# Final Report of Structural Special Inspections

Project: *New 3-Unit Building*  
Location: *62 Cumberland Street; Portland Maine*  
Owner: *Eco Capital, LLC*  
Structural Design Professional in  
Responsible Charge: *David A. Price, PE / Price Structural Engineers, Inc.*  
Date: *July 19, 2011*

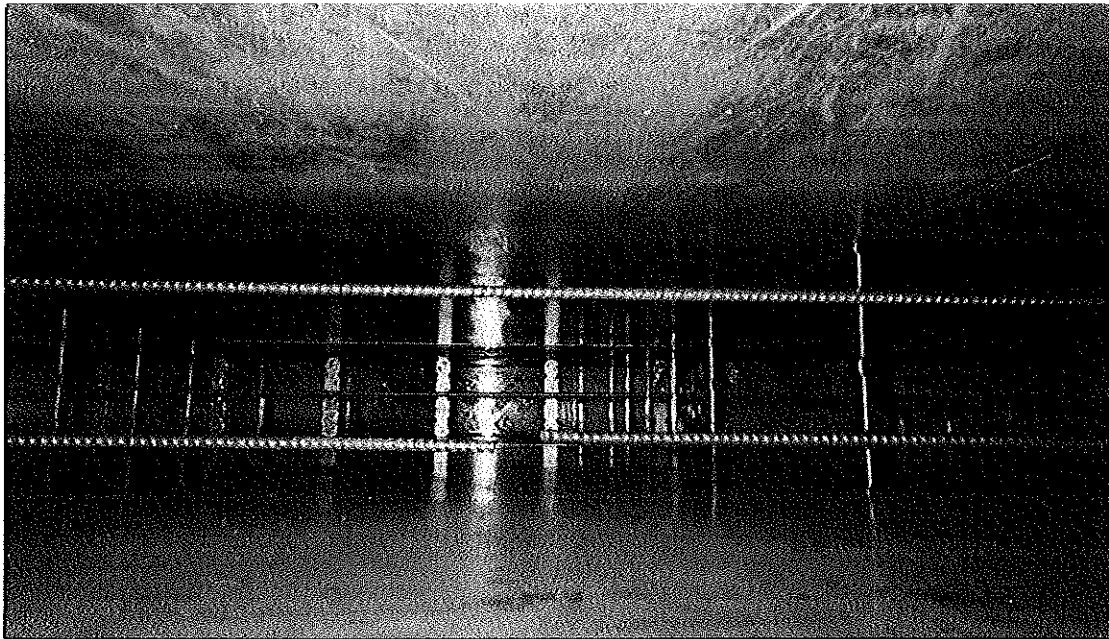
**Lap/Splice length meet minimum requirements of specifications.:**       Vertical       Horizontal  
Describe: \_\_\_\_\_ Hz. Lap and setup inconsistent w/ plans

Vertical bar placed at interior of corner, inconsistent with C3/S3.0  
Missing upper and lower horizontal interior and exterior bar laps.

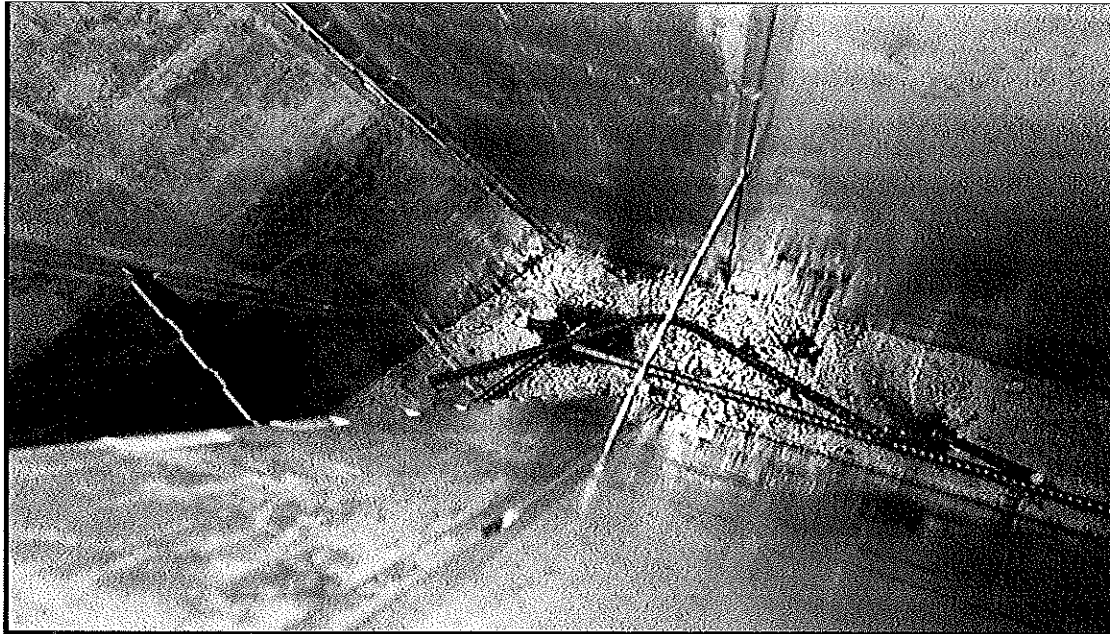
2 inch gap cut out of exterior horizontal bar per E1/S3.0 (Control joint)

Location: Line 4.5 at line D off of Pier

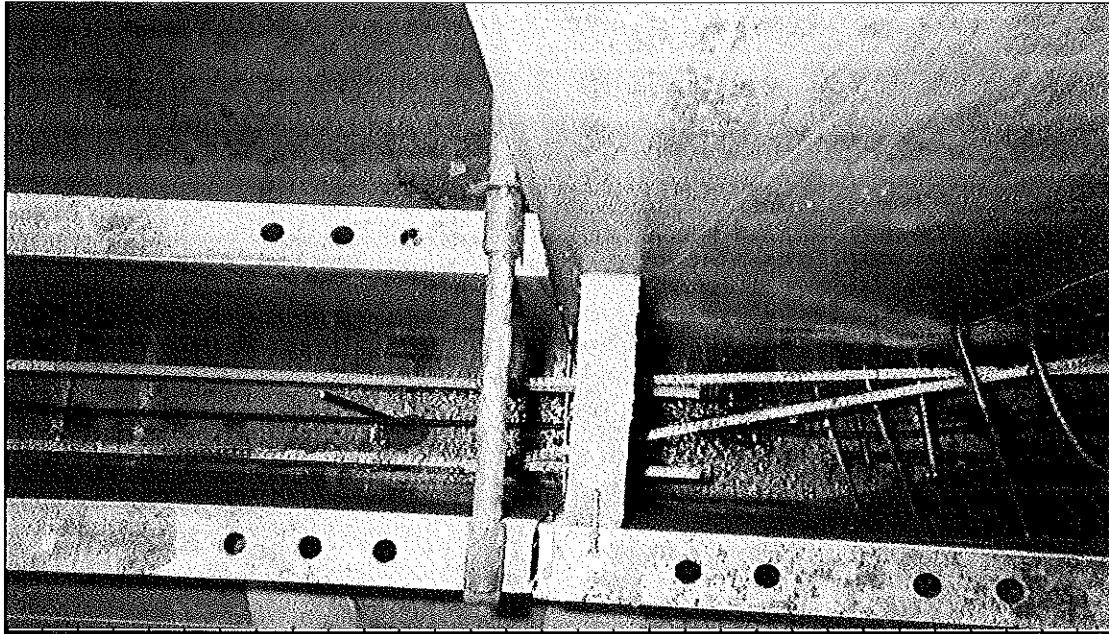
Comments:  
Horizontal lap inconsistent with plan. E.9/S1.0

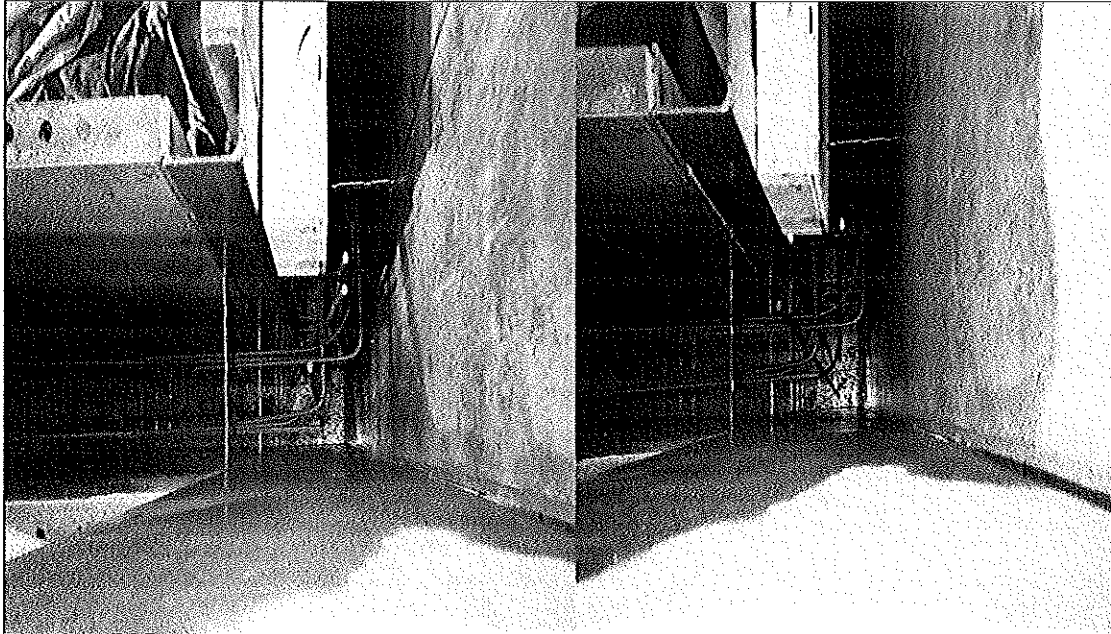
**Lap/Splice length meet minimum requirements of specifications.:**       Vertical       Horizontal  
**Describe:** \_\_\_\_\_ **No lap/connection to running upper Hz. Bars**

**Comments:**  
No lap as per E.9/S1.0

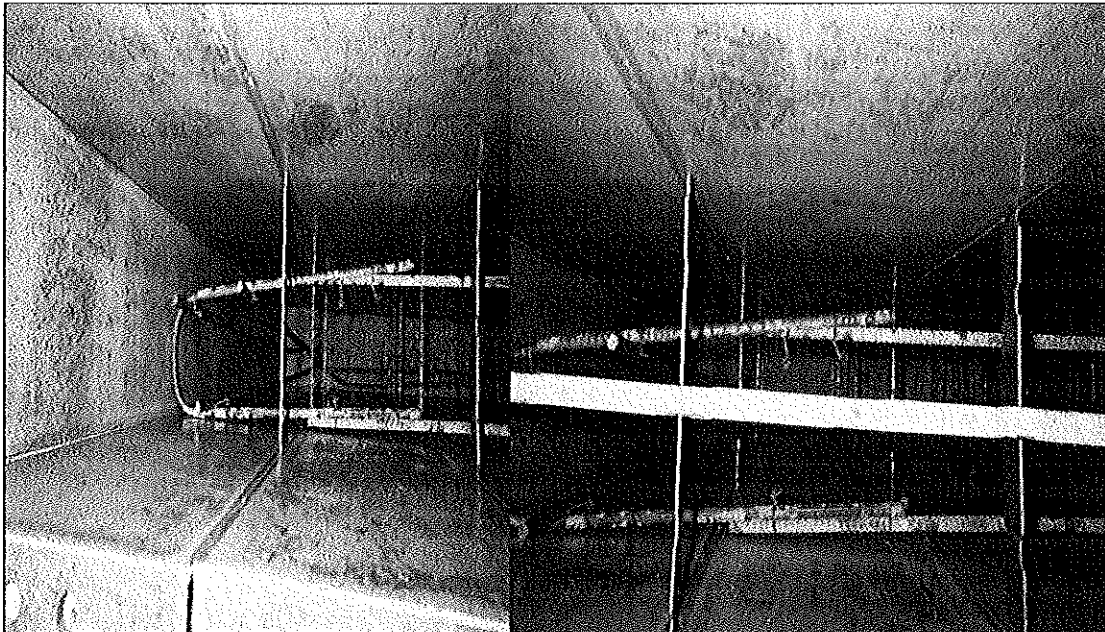
Corner vertical and horizontal bars placement inconsistent with plan. C3/S3.0

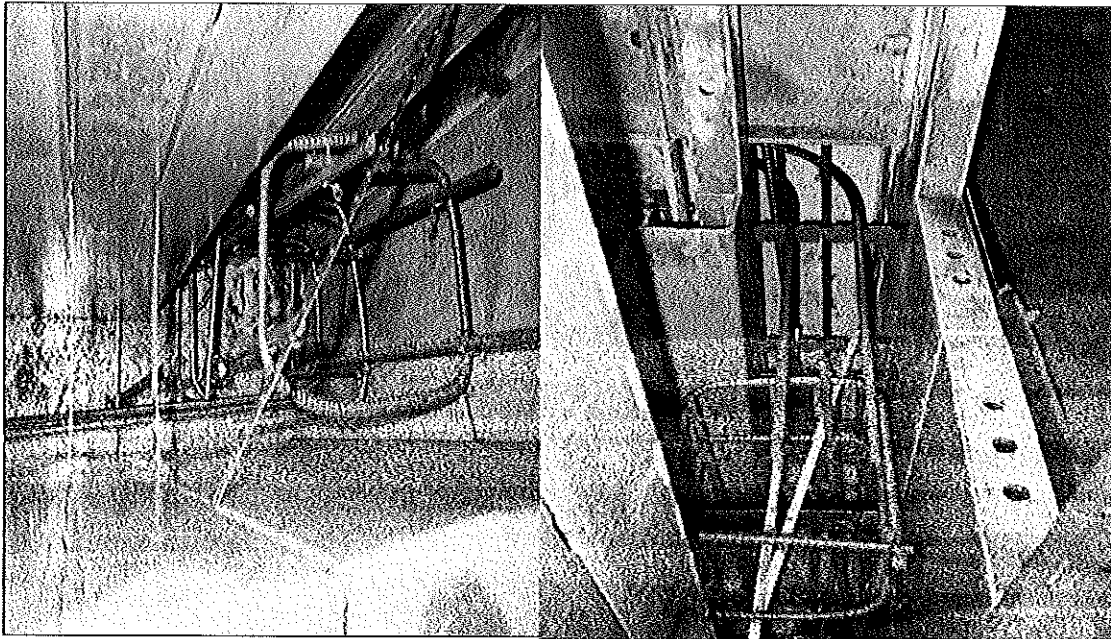
Lap/Splice length meet minimum requirements of specifications.:  Vertical  Horizontal  
Describe: \_\_\_\_\_ Hz. lap approx. 6 in.

Endwall vertical and horizontal bars placement inconsistent with plan. C3/S3.0  
 Upper horizontal bars did not meet lap requirement per E.9/S1.0 (Ruler in picture overexposed due to flash.)  
 Bars at endwall were held away from forms during placement. Exterior upper horizontal bar did not meet clearance specification.

**Photo #2 – Unacceptable steel beam support**

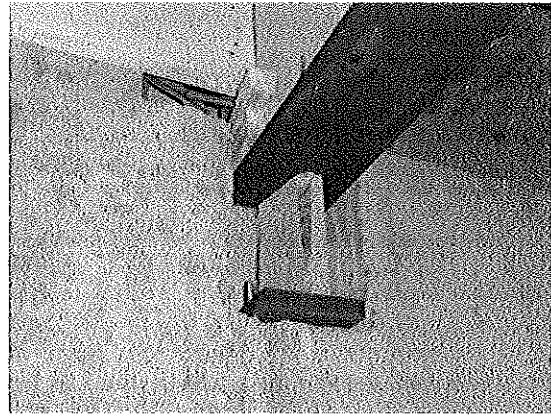
1. Steel beam pocket at grid 11/A.9 was placed too low. Contractor shall provide adequate temporary support of steel beam and infill void below beam with solid concrete (f<sub>c</sub> = 4000 psi). The temporary shoring shall remain in place until concrete has cured a minimum of 7 continuous days unless 2% accelerator or "high early" concrete is used in concrete mix design which would reduce curing period to 3 days.
2. Missing anchor bolts – install 3/4" diameter Hilti Kwik bolts with 4" embedment in concrete per Hilti requirements including, but not limited to hole diameter, cleaning of hole and nut tightness.
3. Joist and beams hangers missing at some joists and beams.
4. Nails missing from some joist and beam hangers.
